THM 700-R4 "UPDATE HANDBOOK"

AUTOMATIC TRANSMISSION SERVICE GROUP

Figure 1

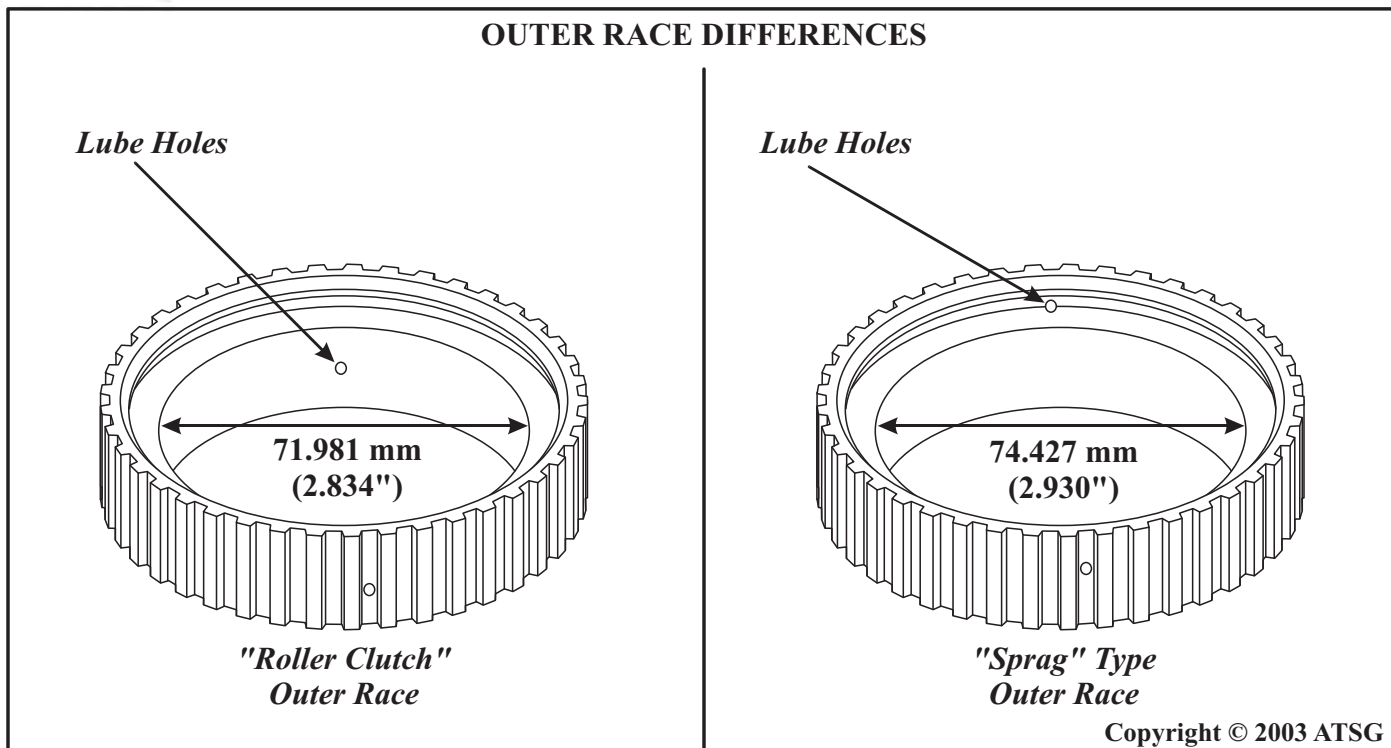
- (1) ROLLER CLUTCH ASSEMBLY - Changed to a Sprag type freewheel with 26 elements, as shown in Figure 1, for greatly increased durability.
- (2) OUTER RACE - Lube hole positions changed and the inside diameter changed, as shown in Figure 2.
- (3) INNER RACE - Pressed on flange added, as shown in Figure 3.
- (4) OVERRUN CLUTCH HUB - Raised area added to each of the tangs on the hub, as shown in Figure 4.
- (5) INPUT SUN GEAR - Shoulder on sun gear was reduced in height, which also reduced the overall height, as shown in Figure 5.

Figure 6

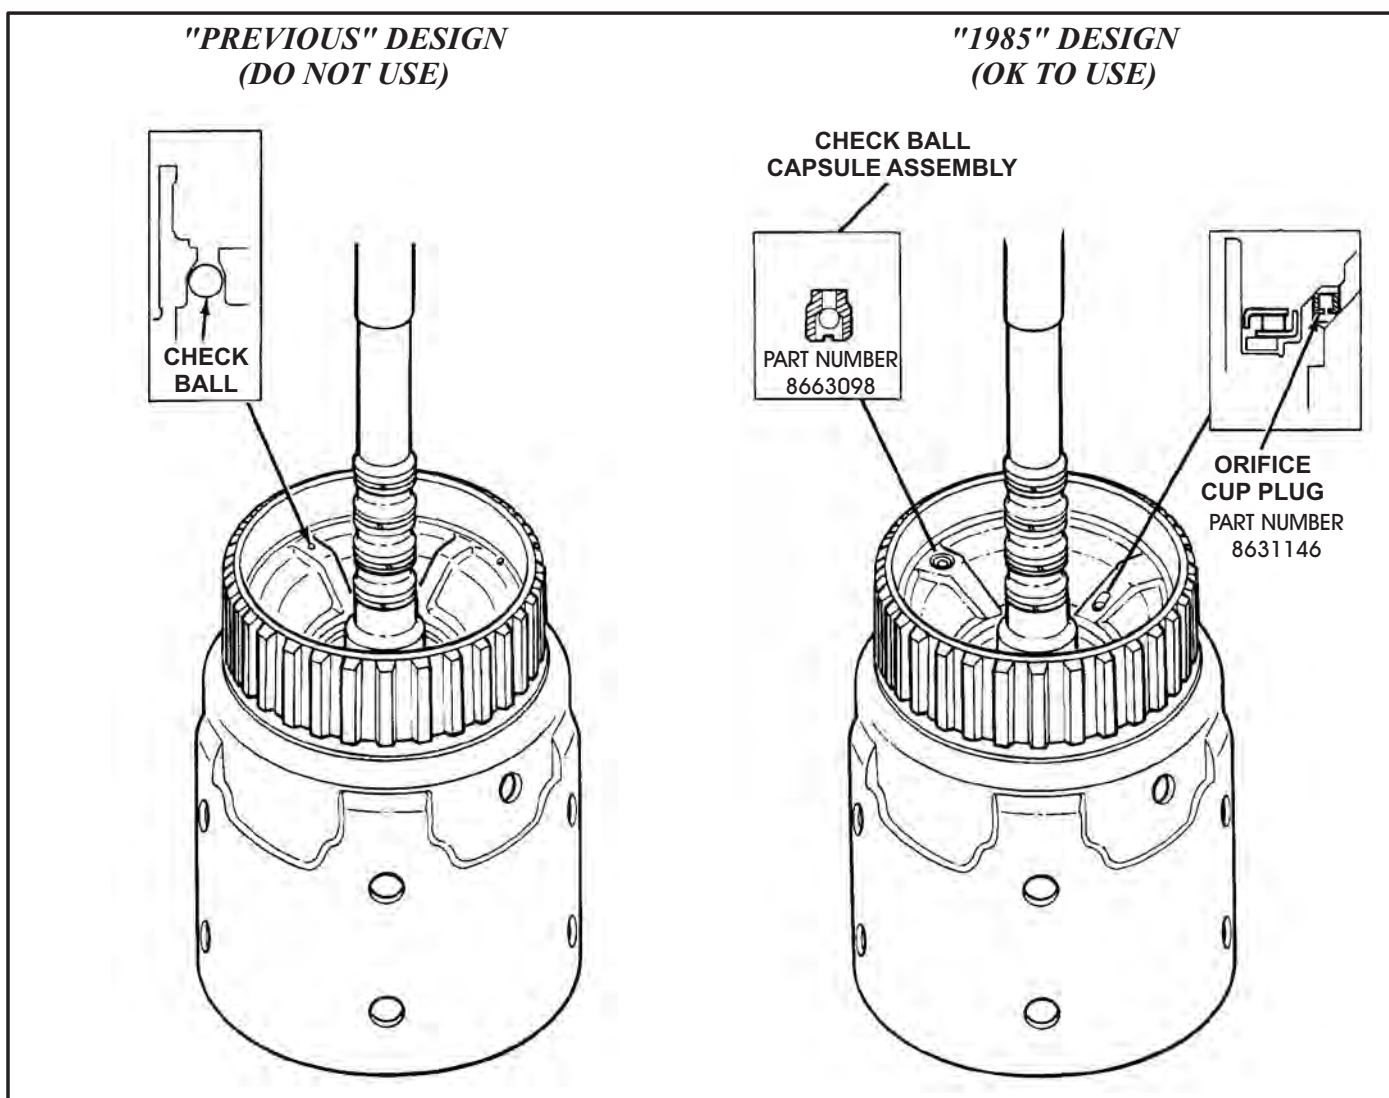
CHANGE: Beginning on January 15, (Julian Date 015) 1984, all THM 700-R4 transmissions were built with a new input housing assembly, as shown in Figure 6. Start of production for 1985, all input housings were also built with an added air bleed cup plug, as shown in Figure 6.

(1) INPUT HOUSING ASSEMBLY - The previous design input housing had a check ball seat drilled into the housing. A check ball was installed into this hole and the opening was then staked to retain the ball, as shown in Figure 6.

The new design **1985** input housing has a check ball retainer assembly which is pressed into the housing, as shown in Figure 6, **and** an added air bleed orifice cup plug.

The new design input housing with the ball capsule assembly and the air bleed orifice cup plug can be used on all past models.

Do not use either of the previous design input housings.

Figure 8

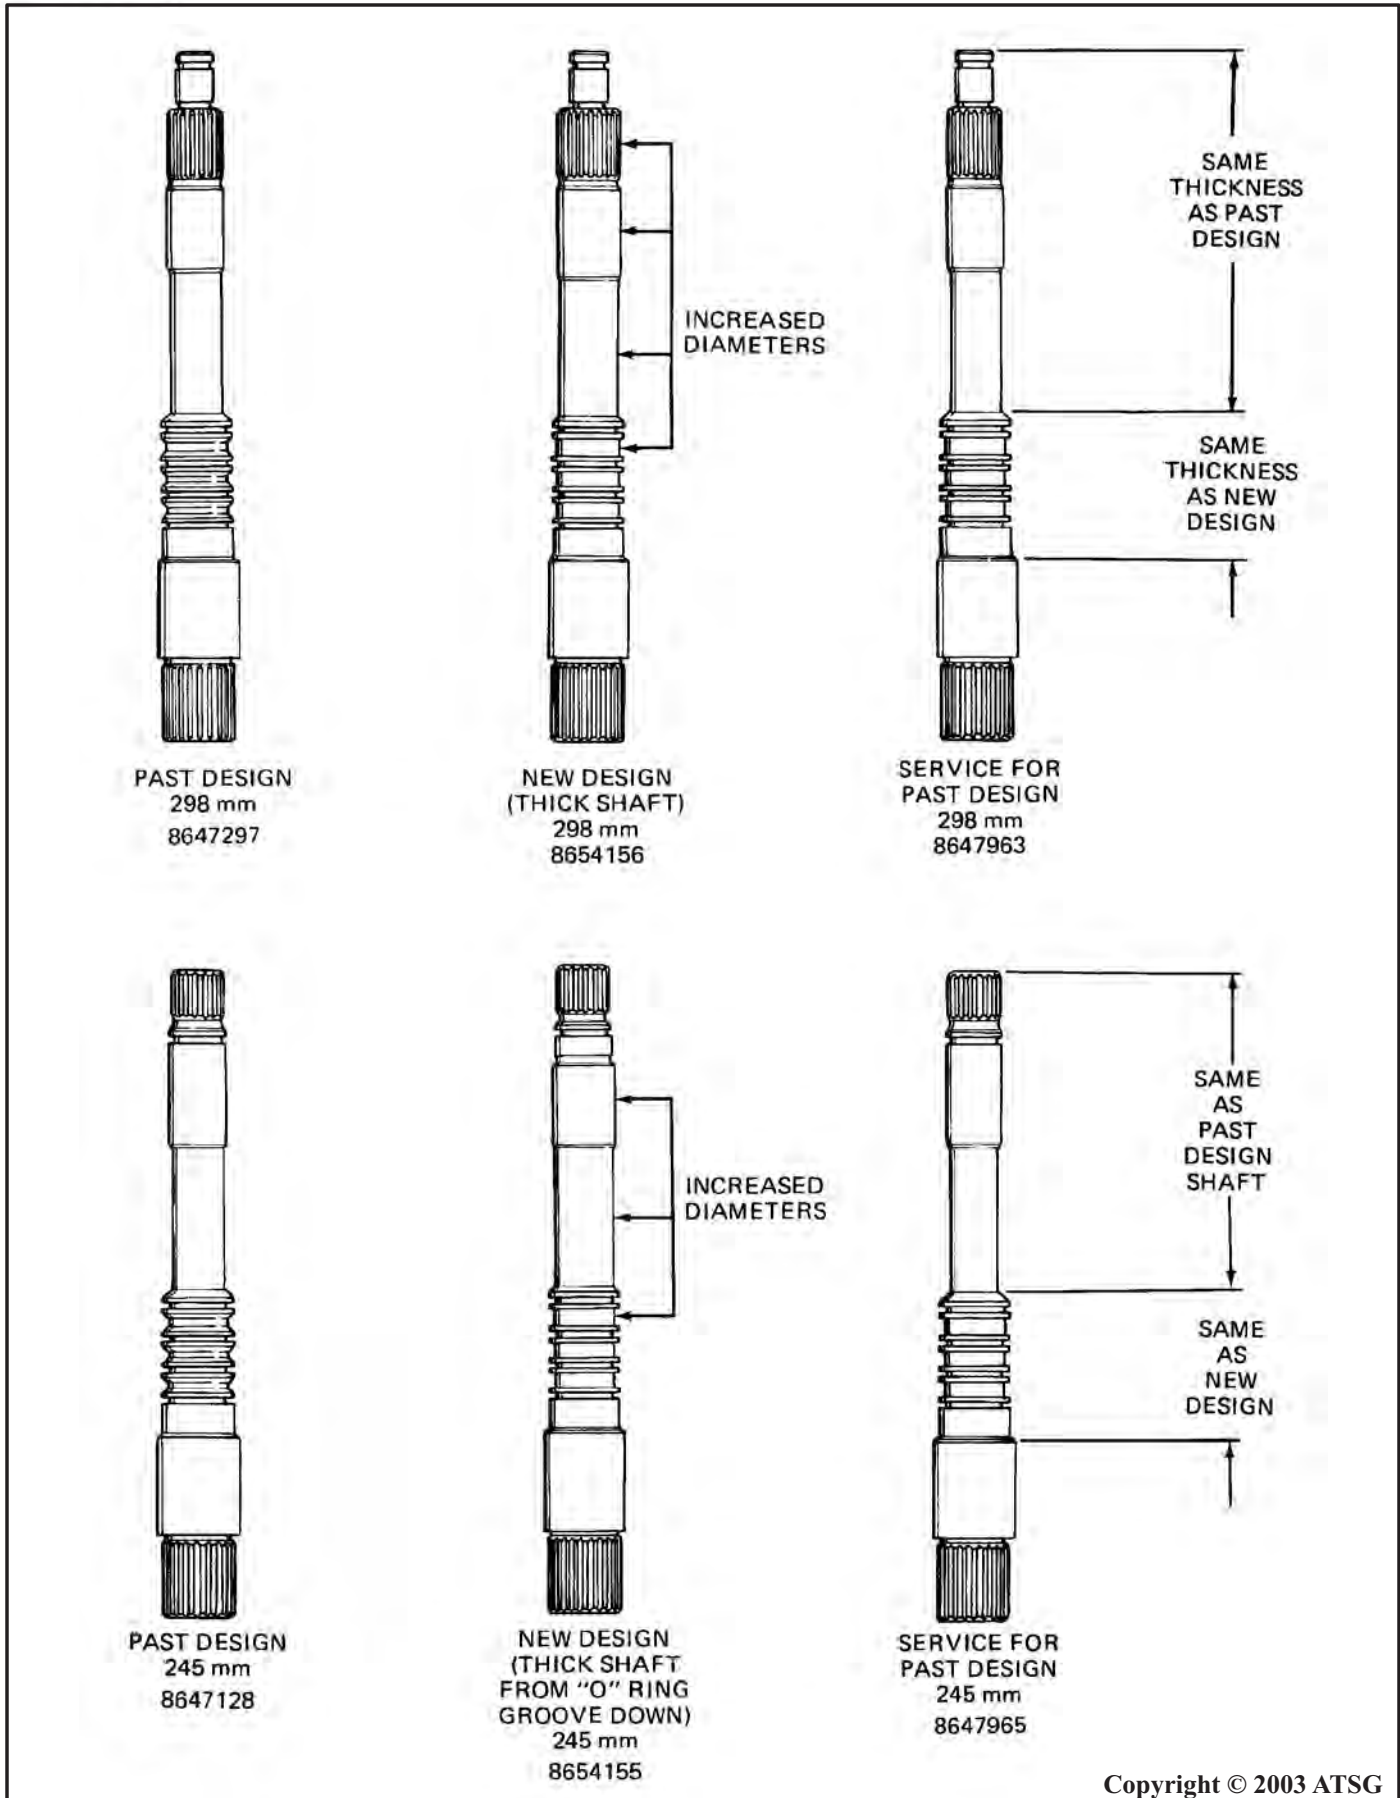
CHANGE: Beginning late in the 1984 model year, Hydra-Matic introduced new design turbine shafts that were larger in diameter, as shown in Figure 8.

- (1) **TURBINE SHAFT** - Increased diameter between the sealing rings, increased diameter of the bushing journal area where it rides in the pump cover, and increased spline diameter for the 298mm converter only, as shown in Figure 8.
- (2) **OIL PUMP COVER** - Increased diameter of the bushing journal area in the stator shaft, to accommodate the increased diameter of the new turbine shaft, as shown in Figure 7.
- (3) **TORQUE CONVERTER** - Increased spline diameter (298mm only) in the converter turbine, to accommodate the new turbine shaft.

In an effort to keep the cost of repairing the transmission to a minimum, another service turbine shaft and input housing was produced to service the 1982 through 1984 models using the original pump cover and torque converter, as shown in Figure 8. The 3rd design turbine shaft is a larger diameter only in the area between the sealing rings where it would crack or break, as shown in Figure 8.

Figure 9

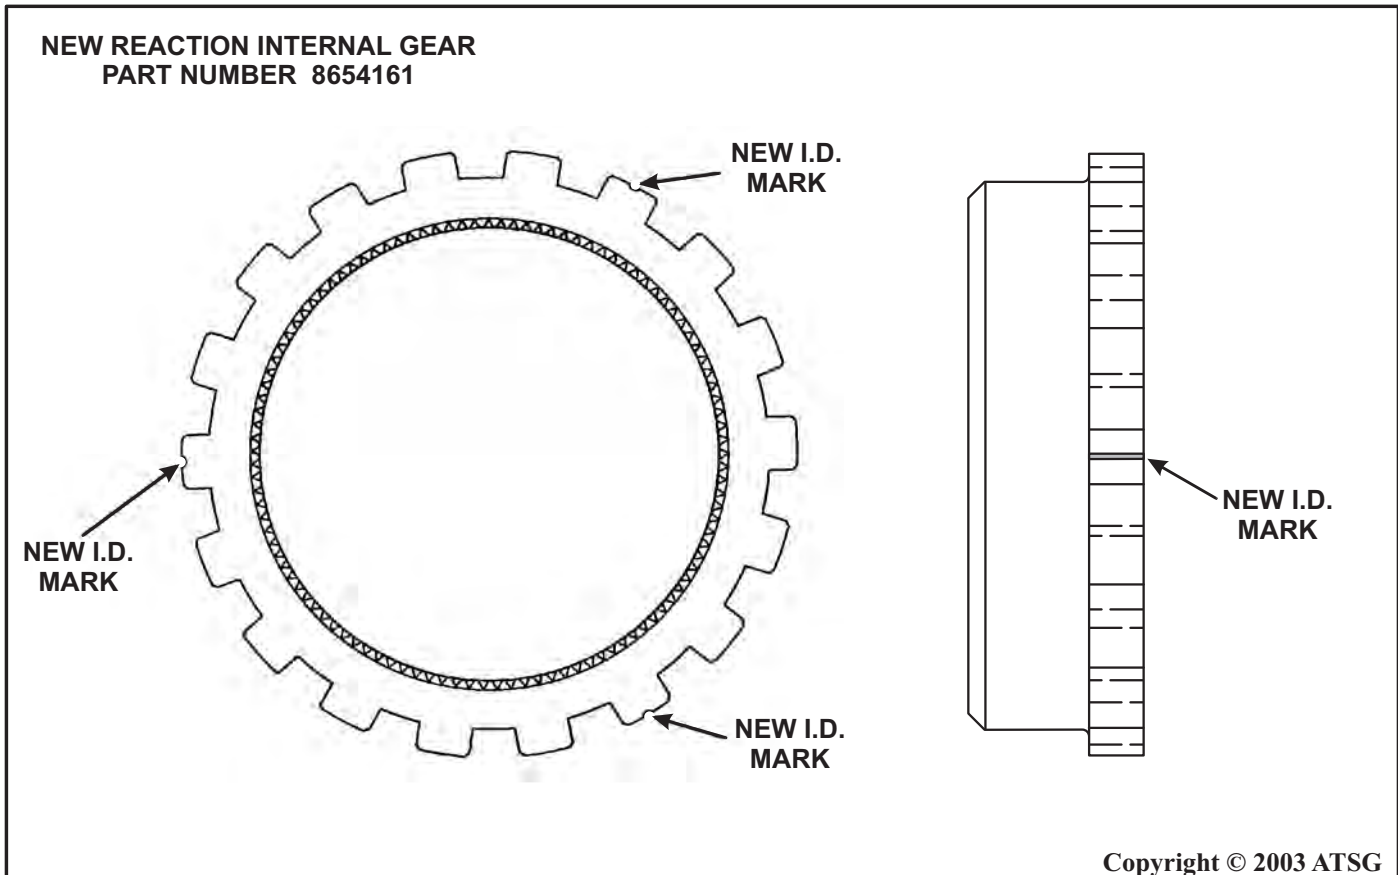
CHANGE: Beginning on January 9, 1984 all THM 700-R4 transmissions were built with a new Reaction Internal Ring Gear, with no dimensional changes, as shown in Figure 9.

- (1) **REAR INTERNAL RING GEAR** - Manufactured with an improved process to eliminate air bubbles from forming inside and prevent ring gear breakage. Since the improved ring gear is dimensionally the same as the previous, identification marks were added. The new ring gear has broached lines on three parking lugs and are equally spaced around the ring gear, as shown in Figure 9.

The new rear internal ring gear will back service all previous models of the THM 700-R4 transmission and is highly recommended to use only the ring gear with markings as shown in Figure 9.

Figure 10

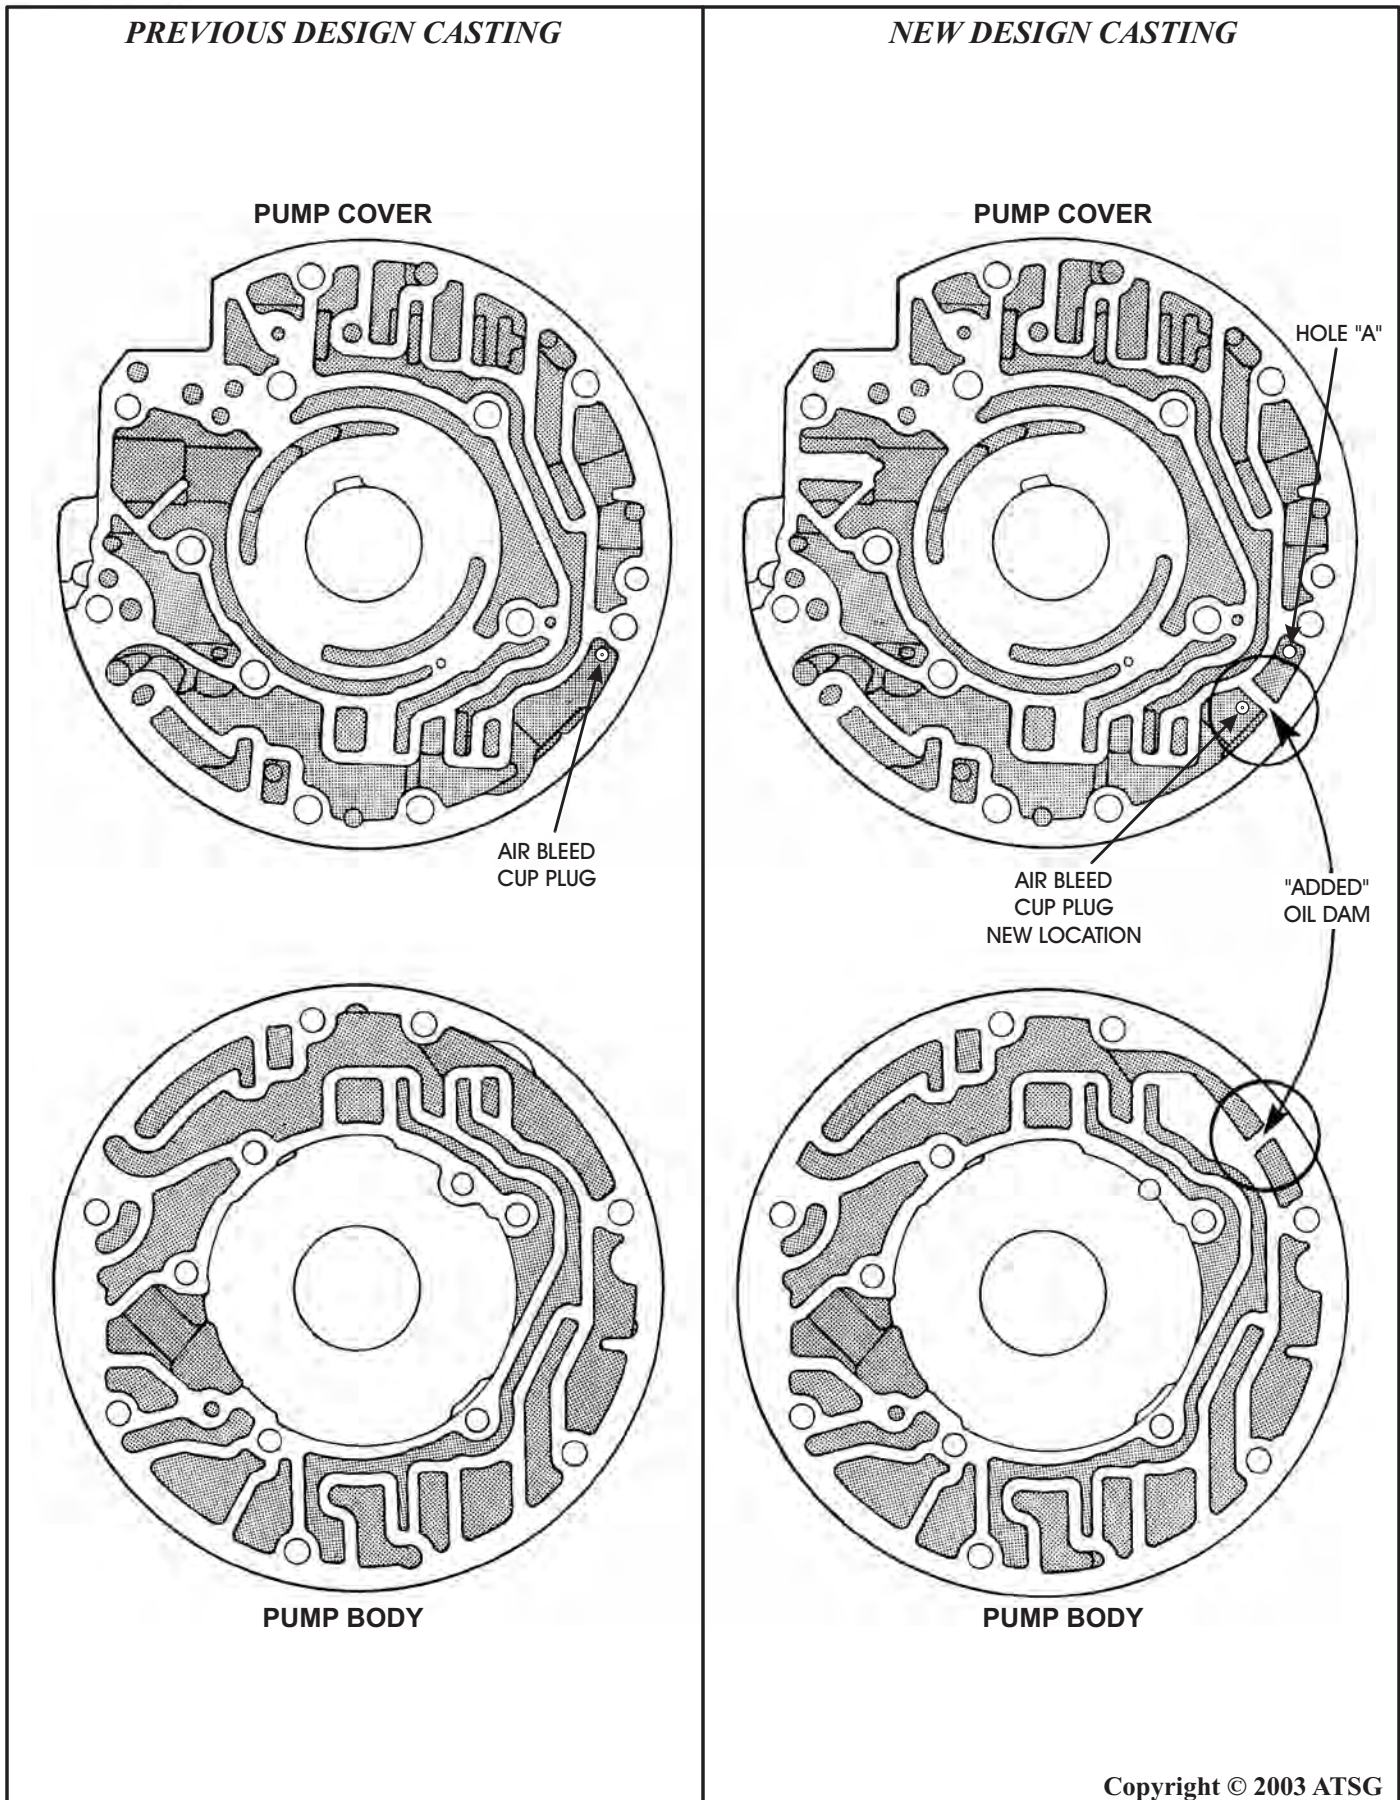
CHANGE: Beginning on June 28, (Julian Date 180) 1984, all THM 700-R4 transmissions were built with a new Pump Body and Pump Cover Assembly with an added oil dam in both components, as shown in Figure 10.

REASON: To reduce oil pump fluid leaks.

- (1) OIL PUMP BODY - Oil dam added to the pump body casting in the line pressure passage, as shown in Figure 10, to prevent the passage from "spreading" and creating fluid leakage. Refer to Figure 10 for the casting changes and Figure 11 for reference casting number locations.
- (2) OIL PUMP COVER - Oil dam added to the pump cover casting in the line pressure passage, as shown in Figure 10, to prevent the passage from "spreading" and creating fluid leakage. This change required the air bleed cup plug to be moved inside of the added dam in the line pressure passage, as shown in Figure 10. Unfortunately, they continued to drill the hole in the pump cover in the location of the previous air bleed cup plug. Refer to Figure 10 for the casting changes and Figure 11 for reference casting number locations.

To use the new design oil pump cover (With Oil Dam), you **must** plug the hole that they continued to drill in the location of the previous air bleed cup plug. Plug the hole marked "A" in Figure 10 to prevent a loss of line pressure that goes over the dam in the cover, because of the lack of the matching dam in the previous pump body. However, if you are experiencing oil pump leakage, you should use the "Dam Type" body and cover.
